#1-87207, B.F. Gilberts Subdv of Tak Park
Takoma Park Hist. Dist., M.P.#37/3

SUBJECT: Preliminary Plan #1-87207, B.F. Gilberts Subdv of Tk Pk

CASE: B.F. Gilberts Subdv of Tak Pk. DATE: April 19, 1995
 (located within Master Plan
 Site #37/3, Takoma Historic
 District)

PRELIMINARY PLAN
 LOTS 53 & 54
 B.F. GILBERT'S SUBDIVISION OF TAKOMA PARK
 MONTGOMERY COUNTY, MARYLAND
 SCALE 1"=30'
 JAN. 1987 (Revised Nov. 1991; Feb. 1995)

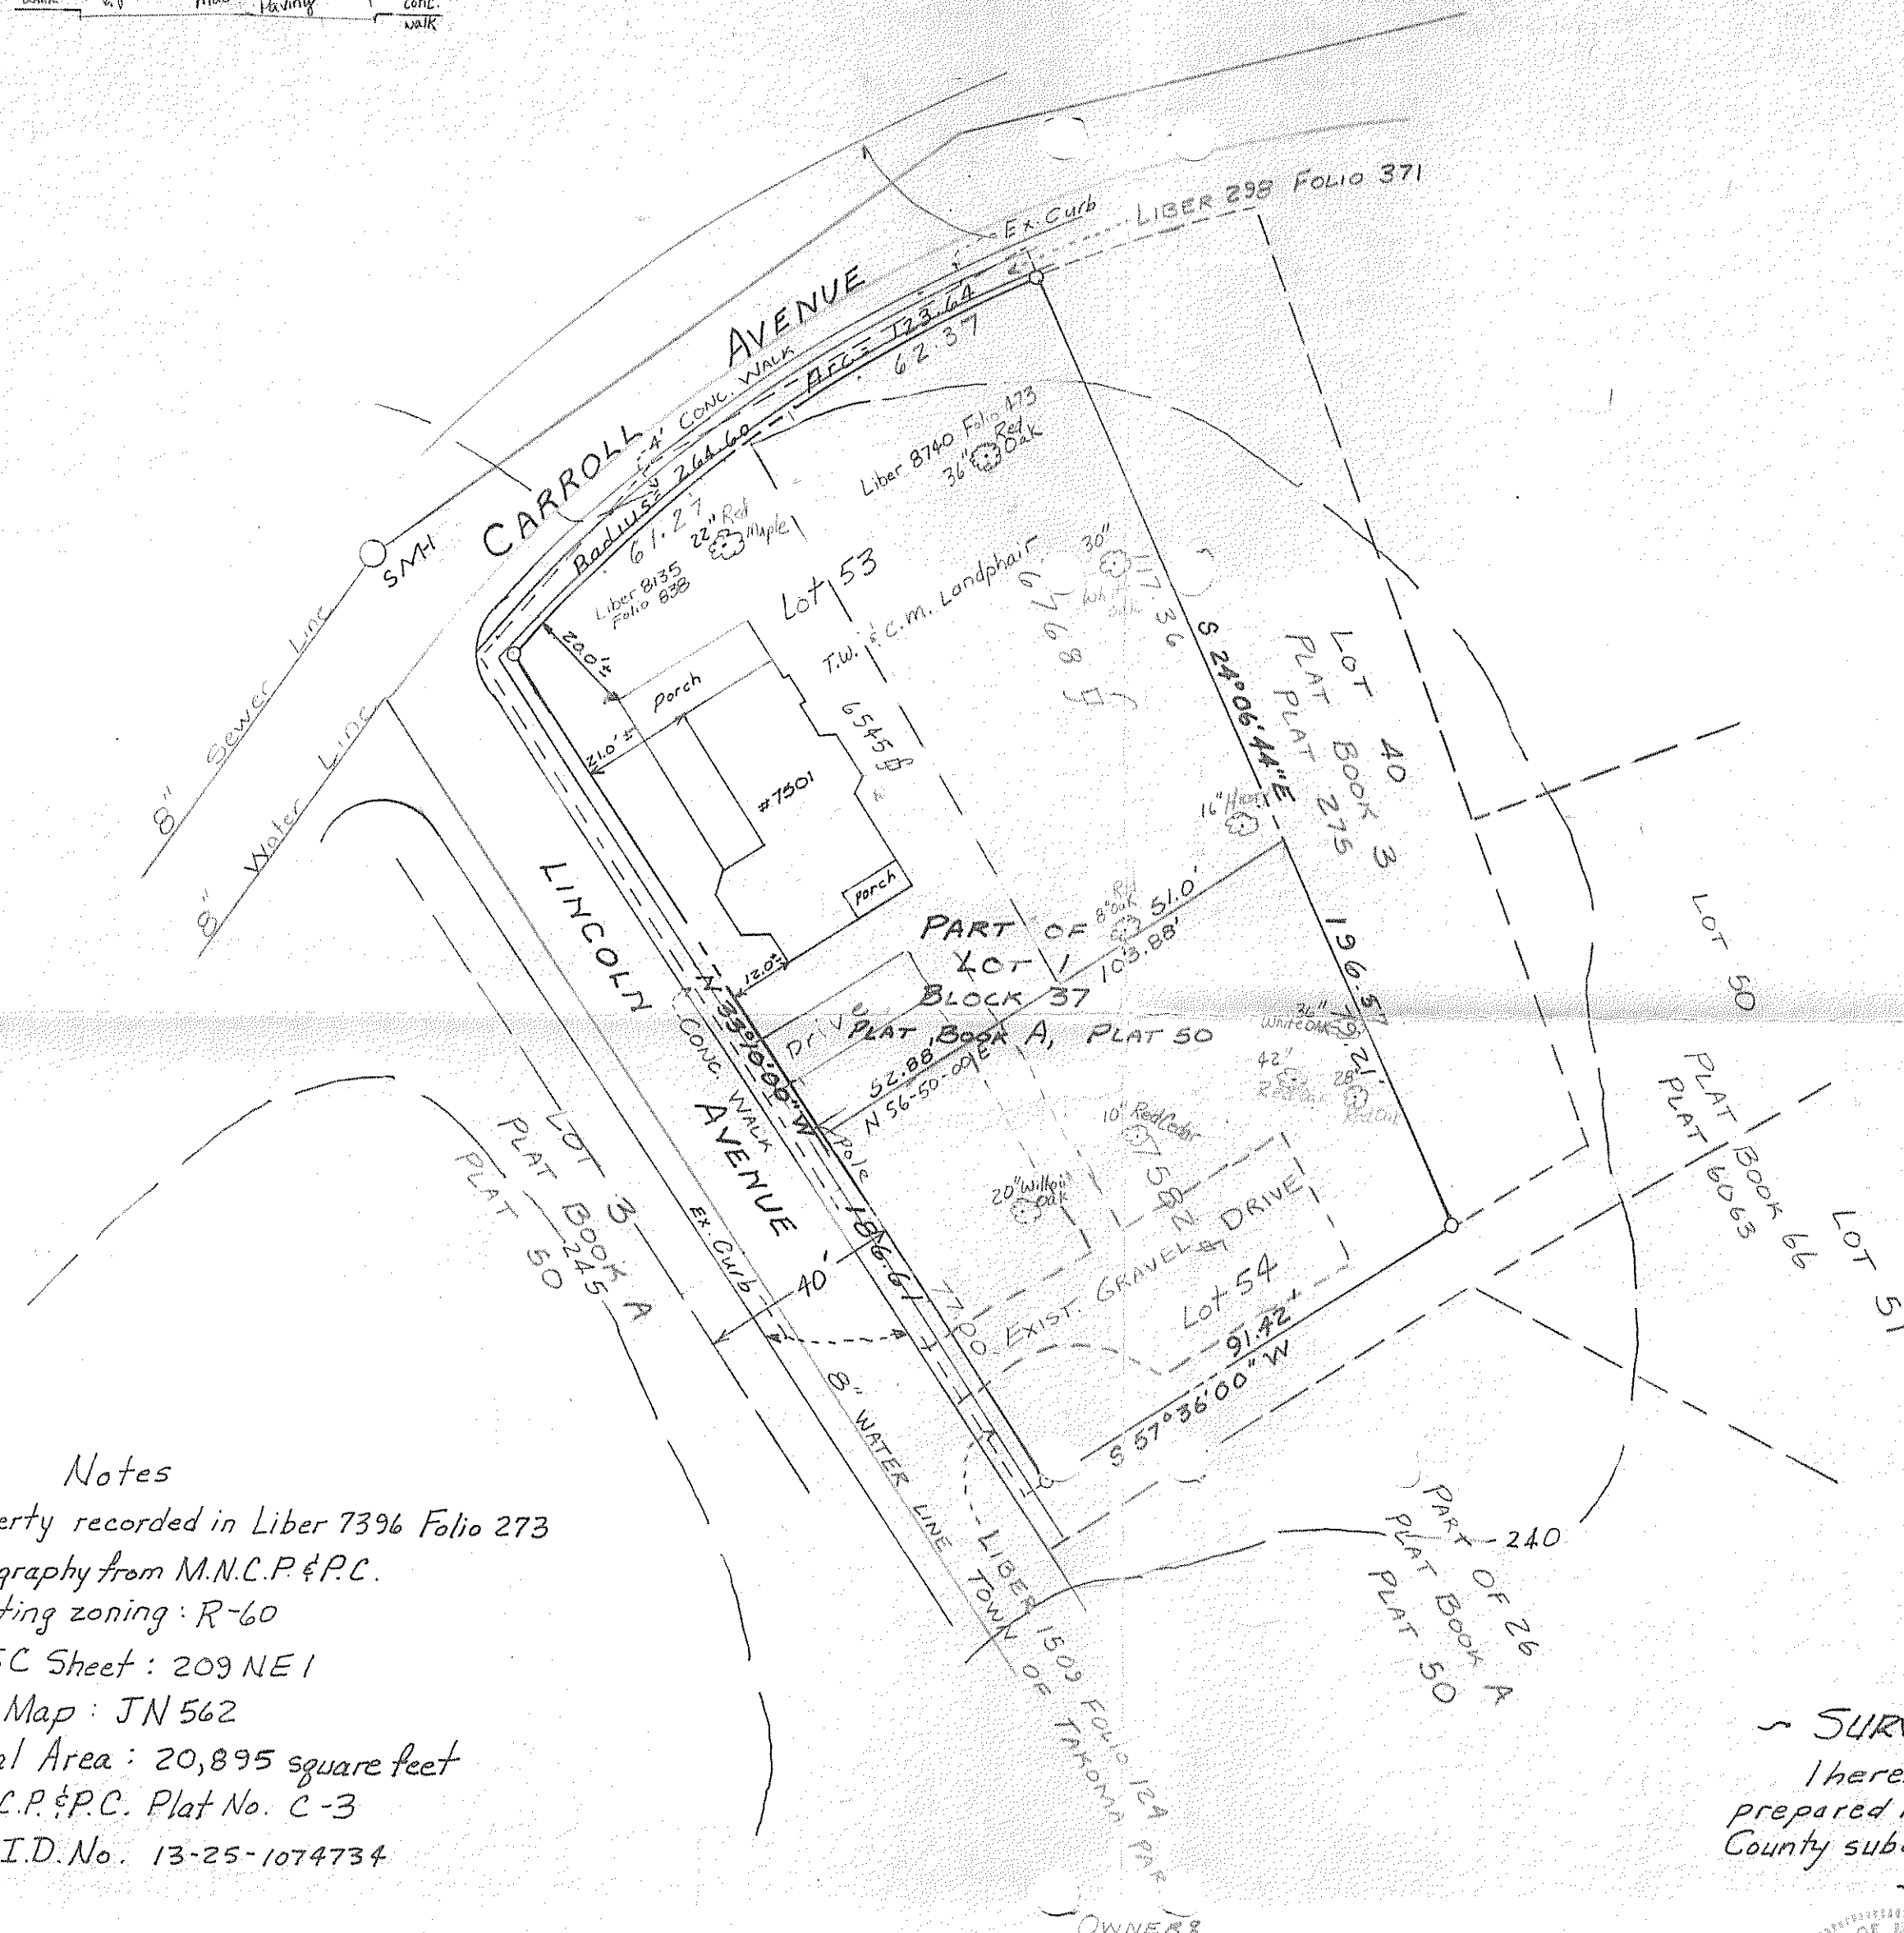
1. Any new construction on Lot 54 must be located so as to preserve existing setbacks and street patterns.
2. Any new access drive/approach to proposed new construction on Lot 54 should be indicated and located so as to be sensitive to patterns within the historic district.
3. Adequate landscape buffering between the existing house property and new construction along the south property line of Lots 53 and 54 will be provided.
4. A tree survey/save plan for the property will be provided.

Staff is concerned about the proposed increase in density (although it is permitted by zoning) and the intrusion which will take place because of proposed new development. The proposal would decrease and alter the existing pattern of open space immediate to the resource.

The Takoma Park Guidelines for Historic Preservation address this concern in its discussion of streetscape and building patterns. The Guidelines state that issues of rhythm, height, massing, side and front setbacks and roof pitch should meet review. Further that patterns of open space, building orientation, outbuildings and preservation of mature tree specimens should ne maintained. Staff recommends that trees at the rear of Lot 54 should be protected and that a tree save plan be submitted.

A new driveway will also be constructed to provide access for the third lot. This will further exacerbate the intrusion experienced by the historic district. Staff recommends that the new driveway be of minimal width to provide access to any proposed improvements.

A mixed hedgerow of deciduous and evergreen trees should be planted along the south lproperty line, from east to west, beginning at Lincoln Avenue. The same treatment should be provided along the property line to the south to screen proposed construction on Lot 54.

1. DRD: applicant to submit new adjacent property owner list, re-notify APO's of application submission with plans and contact Lisa Schwartz of the City of Takoma Park;
2. Put area on Carroll Ave into an easement and dedicate along Lincoln Ave;
3. EPD: three trees on back end of Lot 54 to be protected, recommend a certified arborist verify tree save measures are adequate and plan is exempt from forest conservation (small lot exemption);
4. Historic Preservation: going to HPC April 26, 1995, comments will be forwarded to DRD;
5. PEPCO: need 10' PUE;
6. WSSC: water and sewer connections required and must have easement from Lot 53 to Lot 54 along Carroll Ave;
7. DOT: storm drain study may be required, will notify applicant if one is needed;
8. Tentative Planning Board date is scheduled for May 25, 1995;
9. Complete for queue and application 3/28/95.

- o Any new construction on Lot 54 must be located so as to preserve existing setbacks and street patterns.
- o Indicate the new approach/drive for proposed new construction on Lot 54, sensitive to patterns within the historic district.
- o Provide adequate buffering between the existing house property and new construction along south property line of Lots 53 and 54.
- o Provide a tree survey/save plan for the property.
